**PB03-014**

**Crocker Art Museum Expansion and 2<sup>nd</sup>  
Street Realignment for Parking**

**Provide Board recommendations on the proposed expansion of the Crocker Art Museum and 2<sup>nd</sup> Street Realignment for Parking**

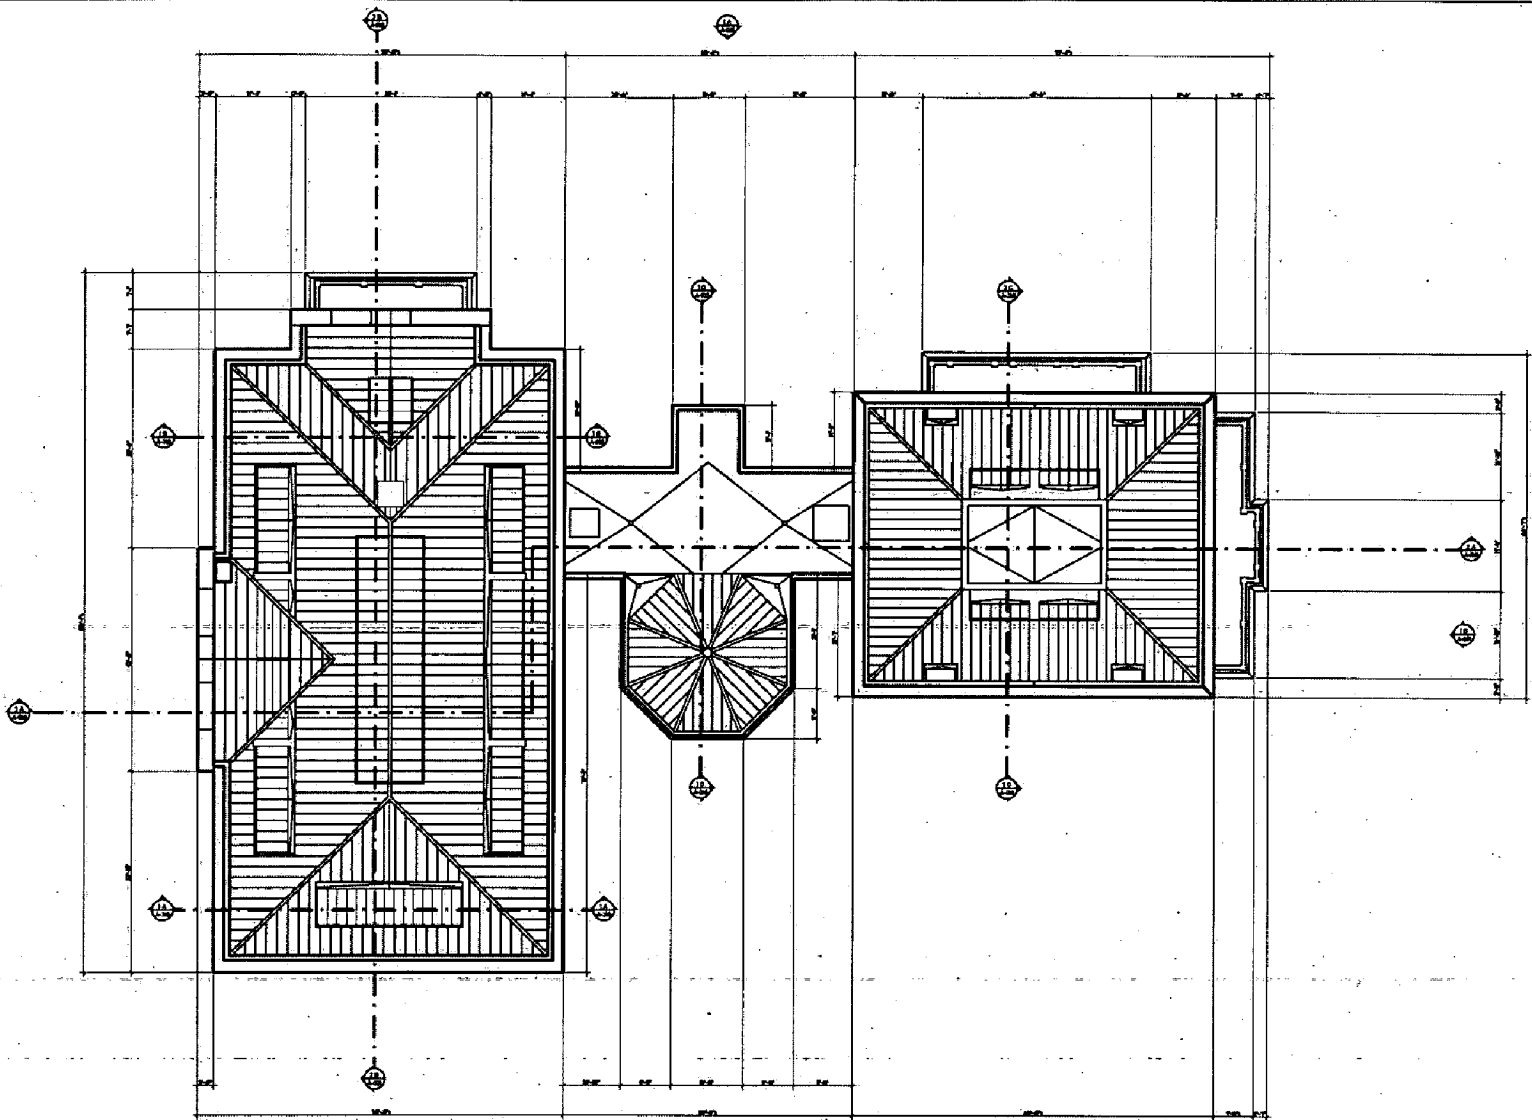
During the Committee's meeting staff questioned the proposed new "gate" over the side entryway stairs leading into a proposed new lower-level west-elevation entry to the historic building. While the "gate" does not physically connect with the historic building, there are potential visual connections/impacts that still strongly concern Staff, and there are discrepancies in the plans relative to this matter that need to be resolved. The attached HMR plans show the "gate's" east edge ending approximately\* one foot west from the historic building's west wall. The attached Gwathmey plans show the "gate's" east edge crossing approximately\* one foot in front of the historic building's north, primary elevation. However the site plan on the Crocker expansion website does not show the "gate" crossing in front of the historic building, but ending back/south from the historic building's front elevation, see attachment last sheet. Staff strongly recommends the HMR option be included in the recommendations to the City's project manager and City Council, as follows:

5. **Gate feature over proposed entry to west elevation of historic art gallery:**  
RECOMMENDATION: That the option shown in the HMR drawings be the recommended option, which shows the east edge of the "gate" maintaining a distance of approximately one foot to the west of the historic building.

\* due to the drawings being reduced and the scale difficult to determine, it appears to Staff that this distance shown is approximately one foot.
